# ENTSO-E response to CENELEC regarding RfG (EU2016/631)

External Project Team / WG CNC

29 May 2017

## **Question 3: Relationship between Article 13 Nr. 4 and Nr. 5**

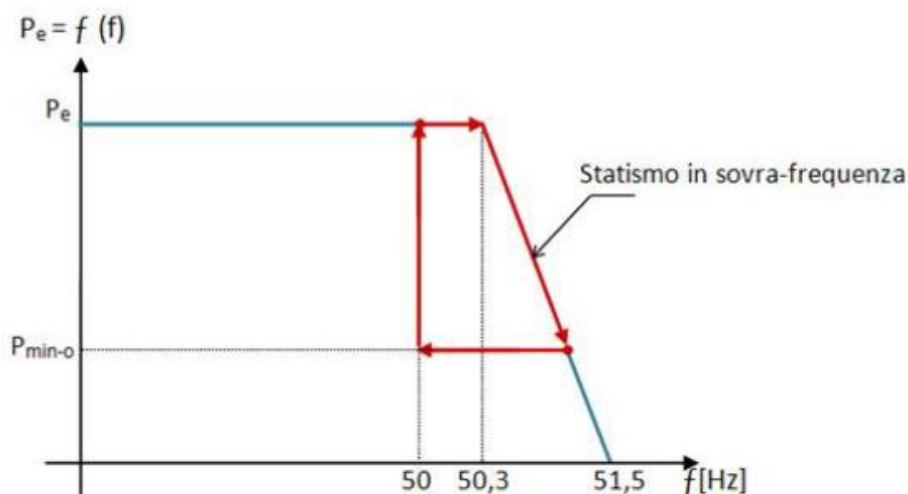
May the taking into account of technical capabilities according to 13 5.(b) result in a higher power reduction than described in Article 13 4. (b)?

No, it cannot. It would moreover address TSO specification on how to choose the values inside the boundaries of provision 13(4)a and 13(4)b

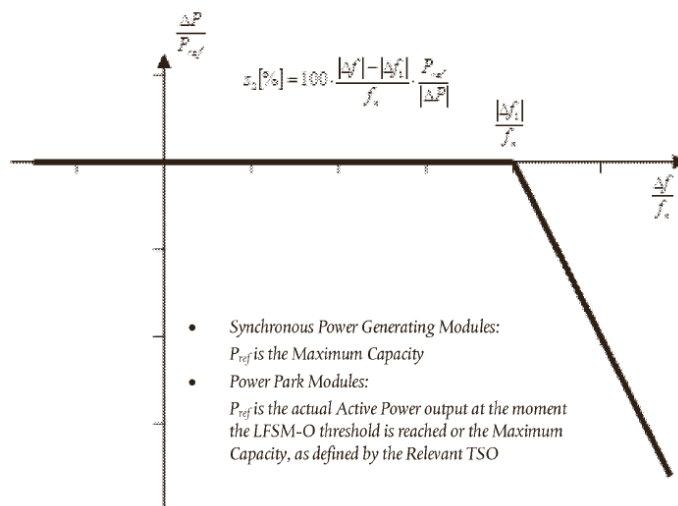
Is a LFSM-O implementation including a hysteresis as proposed below in conflict with Article 13 2?

Article 13(2)(a) defines: “the power-generating module shall be capable of activating the provision of active power frequency response according to figure 1 at a frequency threshold and droop settings specified by the relevant TSO”.

Figure 1 defines the course of the active power frequency response:

Above the frequency threshold to be defined by the relevant TSO, the active power output shall vary in a linear way as a function of frequency. The gradient of the active power variation is defined by the droop, which shall be also specified by the relevant TSO. Article 13(2)(a) does not distinguish between a decrease of active power output in case of increasing frequency and an increase of active power output in case of decreasing frequency, therefore in both cases the linear variation according to figure 1 shall apply. A hysteresis as proposed by CENELEC is not foreseen by the text of Article 13(2)(a).
